Docket Item #2
BAR CASE #2016-00434

BAR Meeting
January 18, 2017

ISSUE: Certificate of Appropriateness for Alterations

LOCATION: 324 South Pitt Street

EXISTING REAR WALL

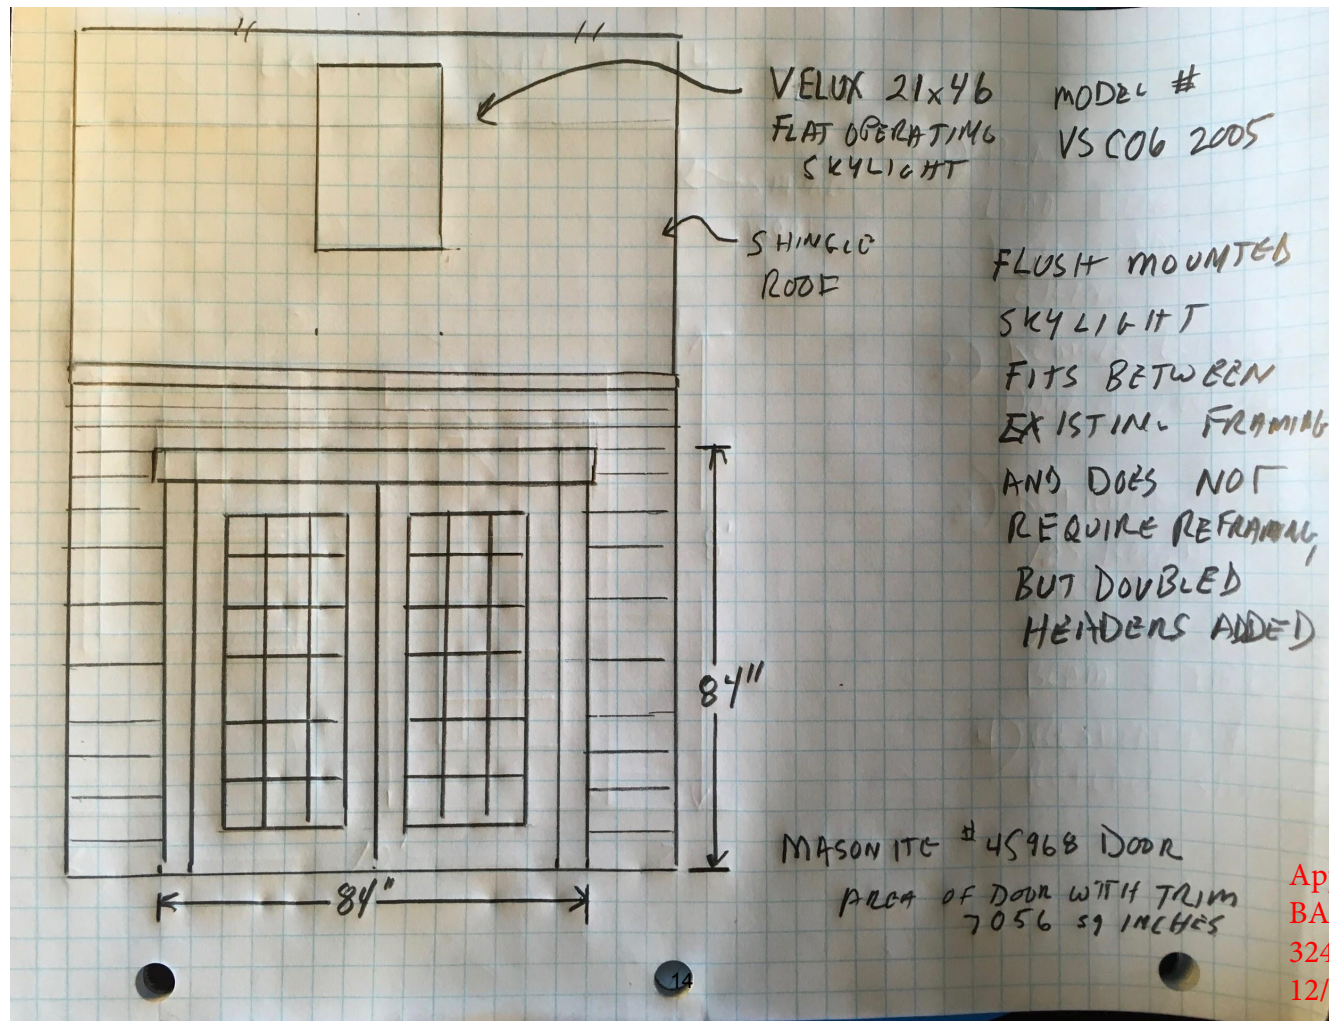
- 1) PLACE TEMP
LOAD BEARING
WALL UNDER
CEILING
- 2) REMOVE EXISTING
DOOR & WINDOW
- 3) REFRAME FOR
735 ROUGH
OPENING
USING 4" STEEL
BEAM & TIE DOWNS
- 4) RESHEATH &
REPLACE SIDING

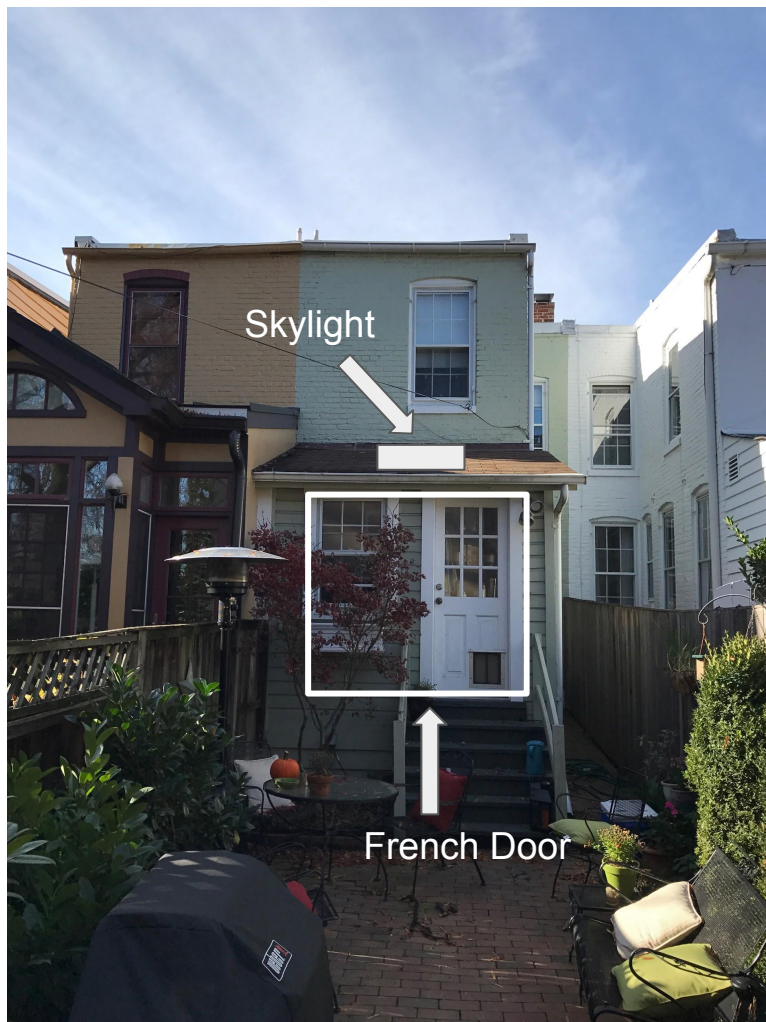
In terms of materials, staff supports the applicant's choice of the 72-inch by 80-inch, Masonite-brand steel doors in "primed white" as suitable for a garden entry. (Figure 4) However, the BAR generally does not approve vinyl materials, and staff questions whether the brickmold vinyl frame is appropriate for this partially-visible architectural element. While it is minimally visible and will not be obvious from the public street, staff recommends that the applicant consider a wood frame or a high-quality composite material that is millable, paintable, and non-reflective. In keeping with BAR criteria and standards, the doors' annealed glass should be clear and have a Low-Emissivity visible light transmittance value of 272 or lower.

The section on skylights in the *Design Guidelines* states that "roof windows" should have a low, flat profile (as opposed to a rounded or domed profile) in order to reduce visibility. While staff supports the deck-mounted, 21-inch by 45.75-inch, Velux-brand aluminum model in concept, staff also questions how prominent the profile will be in height and whether this is the most flush option of operable skylights available on the market? Staff also recommends that the flashing should match the color of the roofing material to reduce visibility. (Figure 5)

1. All new windows must meet the Alexandria Replacement Window Performance Specifications contained in the BAR's adopted window policy. Specifically, the skylight:
 - a. Should have a low, flat profile to reduce visibility.
 - b. The flashing should match the color of the roofing material to reduce visibility.
2. All new and replacement doors and trim must comply with adopted BAR policies.
 - a. The French doors' glazing must comply with the Alexandria Replacement Window Performance Specifications in that the annealed glass VLT must be Lo-E 272 or lower value.
 - b. The doors' brickmold frame should be either wood or a high-quality composite material that is paintable, millable, and non-reflective rather than vinyl.
